From: [Jon Murray](#)
To: [Guy Evans](#)
Subject: RE: St Marys Freight Terminal
Date: Tuesday, 23 June 2020 3:39:45 PM
Attachments: [image001.png](#)
[RE St Marys Freight Terminal.msg](#)
[Re St Marys Freight Terminal.msg](#)
[RE St Marys Freight Terminal.msg](#)
[RE 11579 - Website enquiry from Jonathon Murray.msg](#)

As discussed the tree size specified in the DA documents would need considerable lead time and even then most nurseries will not stock these types of species in the specified size. We attached emails and substation recommendations from several large nurseries in the Sydney area which show that no 75L sizes in these species are currently available.

We would seek to have the condition adjusted so that a pot size of 25-45L is permissible for this project given the availability from the Nurseries mentioned. We believe the same outcome will be achieved in doing so, with the over all install heights only varying slightly from the proposed 75L trees.

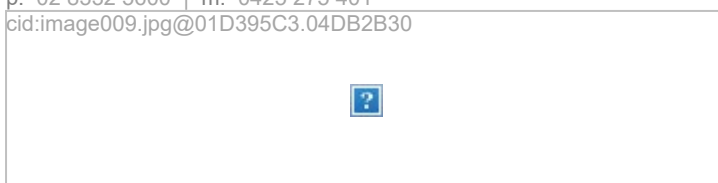
TREES		BOTANICAL NAME	COMMON NAME	HEIGHT	WIDTH	POT SIZE	SPACING	QUANTITY
Af	<i>Angophora floribunda</i>	Roughbarked Apple	7P	20	15	75Ltr 45H	As Shown	45
Cg	<i>Casuarina glauca</i>	Swamp She-oak	8P	20	10	75Ltr 45H	As Shown	7
Em	<i>Eucalyptus moluccana</i>	Grey Box	7P	30	15	75Ltr 45H	As Shown	34
Et	<i>Eucalyptus tereticornis</i>	Forest Red Gum	60/59	30	15	75Ltr 30mm	As Shown	32
Ms	<i>Melaleuca styphelioides</i>	Prickly-leaved Tea Tree	5P/56	20	10	75Ltr 45H	As Shown	28

Mel leucophylla
